## **DETAILED ACTION**

Claims 1, 6, 9-14, 21, and 26-27 are rejected under 35 U.S.C. 103(a) as being unpatentable over Tanaka et al (US Patent 4,934,836) in view of Moritan (US Patent 5,715,116).

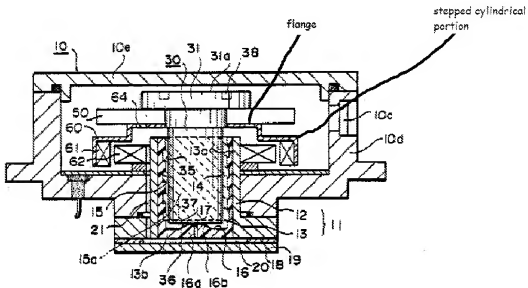
Regarding claim 13, the hub further includes a flange and a stepped cylindrical sidewall extending from the flange and circumscribing at least a portion of the base (see figure below).
